COUNCIL ASSESSMENT REPORT

HUNTER AND CENTRAL COAST REGIONAL PLANNING PANEL

PANEL REFERENCE & DA NUMBER	PAN/458363 – DA/1264/2024			
PROPOSAL	Coastal Protection Works (Section A)			
ADDRESS	3-17 Calais Road, Wamberal Remembrance Drive (Wamberal Beach) Council Land and Road Reserve			
LOTS AND OWNERS	Lot	Plan	Address	Owner
	CALAIS ROAD			
	75	DP 13304	3 Calais Road	R Hill C Hill
	74	DP 13304	5 Calais Road	Aldwych Industrial Finance
	73	DP 13304	7 Calais Road	Simberth Pty Ltd
	72	DP 13304	9 Calais Road	T Ohannessian
	71	DP 13304	11 Calais Road	B P Bailey J M Bailey
	Lot 0 CP	SP 54686	13 Calais Road	SP 54686
	69	DP 13304	15 Calais Road	C R Byrne
	Lot 0 CP	SP 73507	17 Calais Road	SP 73507
APPLICANT	Mr Chris Rogers			
DA LODGEMENT DATE	20 August 2024			
APPLICATION TYPE	Development Application			
REGIONALLY SIGNIFICANT CRITERIA	Section 2.19(1) and Clause 3 of Schedule 6 of <i>State Environmental Planning Policy (Planning Systems) 2021</i> declares the proposal regionally significant development as: 3 Council related development over \$5 million <i>Development that has an estimated development cost of more than \$5 million if—</i> <i>(a) a council for the area in which the development i

Figure 14 – Typical Engineering Detail - 3 Tier Design

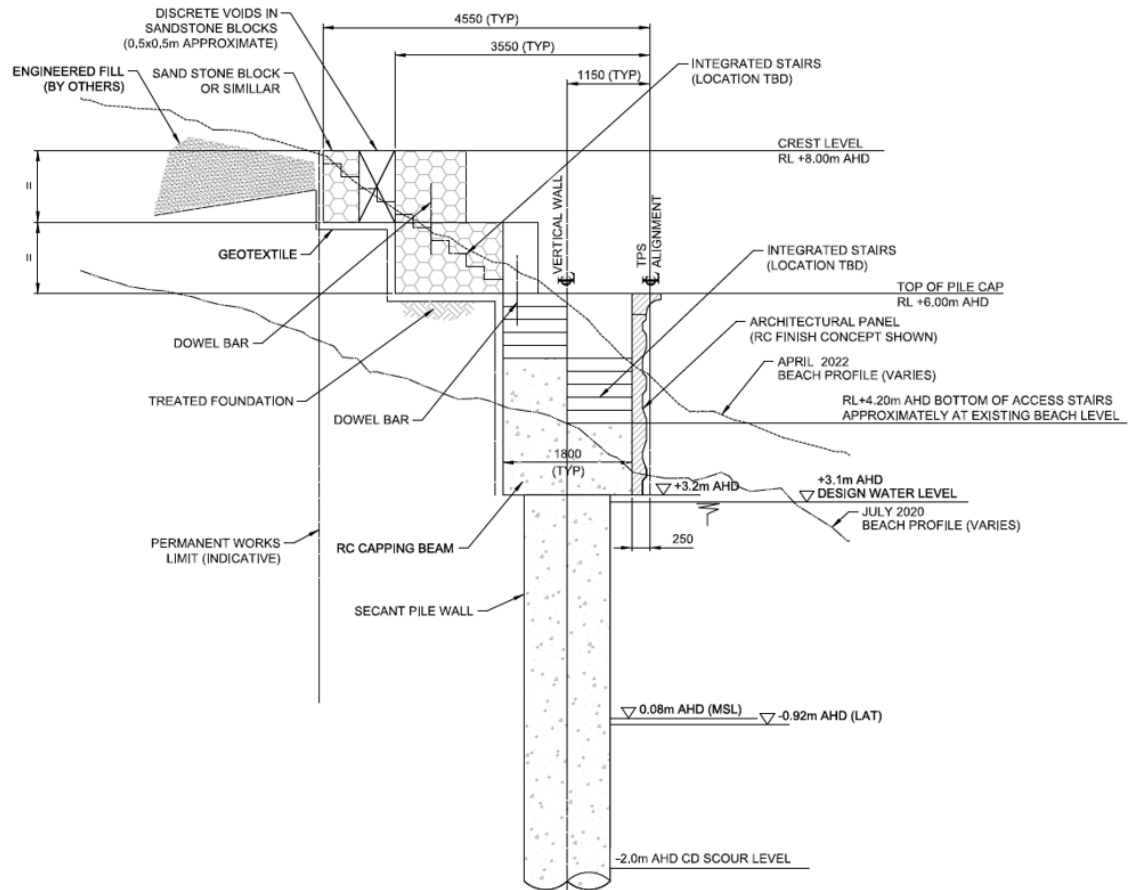
The submitted engineering drawings provide a typical sectional detail of the terminal protection structure. An excerpt of the detail for the 3 Tier Design is provided in **Figure 14**. The detail demonstrates the potential for significant fill required behind the wall and the potential for significant variation in the perceived wall height depending on the sand level at each property. The engineering 'typical detail' has not been translated onto sectional landscape drawings that address the level conditions at each property (or a sampling of properties).

1. **Structural Stability:** *The structure submitted on the DA drawings has not been designed for the appropriate coastal process conditions, but the applicants' response states that would be done in detailed design. This should have been done for the concept design presented for approval. With a -2 m scour level, the design condition comprises a 10 m high cantilevered concrete secant pile wall, which is a severe design*
